Docket Number:	17-BSTD-01
Project Title:	2019 Building Energy Efficiency Standards PreRulemaking
TN #:	221556
Document Title:	An Alternative Kitchen Exhaust Fan Sone Metric for Better Results
Description:	N/A
Filer:	System
Organization:	Newport Ventures
Submitter Role:	Public
Submission Date:	10/20/2017 8:23:56 AM
Docketed Date:	10/20/2017

An Alternative Kitchen Exhaust Fan Sone Metric for Better Results

Re: Docket 17-BSTD-01, Proposed Kitchen Exhaust Fan Sone Requirements, Section 150.0(o)2 and Section 120.1(b)2b

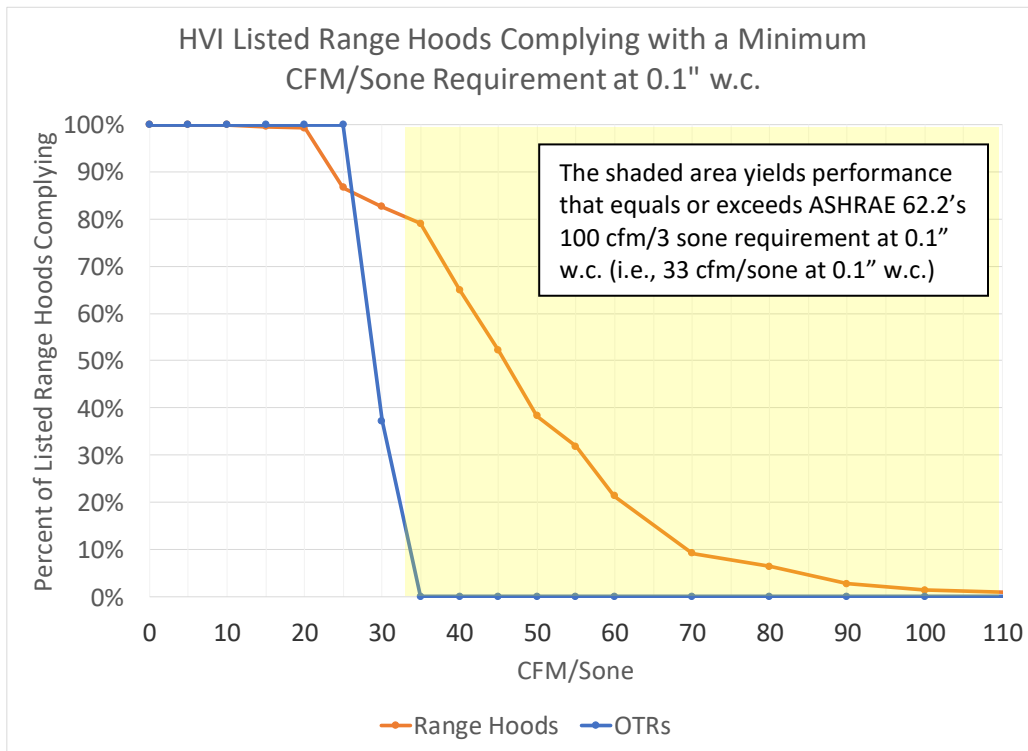
target of > 30 cfm/sone at 0.1" w.c. This would equate to 3.3 sones at 0.1" w.c. at 100 cfm, and is a little bit noisier than the ASHRAE target.

If CEC elected to mandate this metric (i.e., > 30 cfm/sone; see the yellow highlighted row in the table below), it would result in the following compliance levels for models listed in the HVI database at 0.1" w.c. with a flow >= 100 cfm:

- 78% of all models would comply (1096 models)
- 37% of OTRs would comply (48 models; note that OTRs were just listed in June, so this will likely increase in the future)
- 83% of range hoods would comply (1048 models)

CEC may want to be more aggressive than this, to be more in keeping with the ASHRAE 62.2 target of 3 sones at 100 cfm. If the metric were set at > 35 cfm/sone, this would put us at 2.8 sones at 0.1" w.c. for a 100-cfm range hood, which is better aligned with the ASHRAE 62.2 target of 3 sones at 100 cfm. At this level, there would not be any OTRs that currently qualify (though 79% of range hoods still would; see the blue highlighted row in the table below). Perhaps this is okay, because OTRs are notoriously poor performers with respect to capture efficiency, quieter fans will get better use resulting in better IAQ and occupant health, and there's nothing stopping better performing OTRs from meeting this spec.

Increasing the cfm/sone requirement further, to say, 40 cfm/sone would trigger a rapid decline in compliant range hoods and would push the limitations of economy hood performance (at least for now). See the graph and table below for more information with respect to compliance outcomes associated with various cfm/sone scenarios. These data were sourced from the HVI database in August, 2017.

On the basis of this analysis, following is a proposed amendment to 62.2 for California that would establish a minimum cfm/sone metric for range hoods. I've included the phrase "for each of its listed duct orientations and dimensions" to avoid gaming. For example, horizontal ducting generally produces lower sones, but vertical ducting is thought to be the most common in the field. Requiring all listed orientations and duct dimensions to comply with the metric would ensure that a range hood that complies in one orientation is not installed in a non-compliant orientation in the field. Additionally, this will make it easier to coordinate with the Title 20 appliance efficiency database down the road. Also, the proposed language changes the reference in Title 24 from "kitchen range hoods" to "kitchen exhaust fans". This is critical because ASHRAE 62.2 permits non-range hood products such as down drafts, in-line fans, and ceiling- or wall-mounted fans to be used to exhaust kitchens. As such, 62.2 uses the term "kitchen exhaust fans" when establishing minimum sone requirements. Unless the Title 24 language is changed to align with 62.2 and read "kitchen exhaust fans" the Title 24's proposed sone requirements would not apply to these product classes.

7.2.2 Demand-Controlled Local Exhaust Fans. Bathroom exhaust fans used to comply with Section 5.2 shall be rated for sound at a maximum of 3 sones. Kitchen exhaust fans used to comply with Section 5.2 shall be rated for sound to exceed 35 cfm/sone at a minimum of 0.1 in. wc (25 Pa) static pressure for each of its listed duct orientations and dimensions at a maximum of 3 sones at one or more airflow settings greater than or equal to 100-cfm (47 L/s). Exception: Fans with a minimum airflow setting exceeding 400 cfm (189 L/s) need not comply.
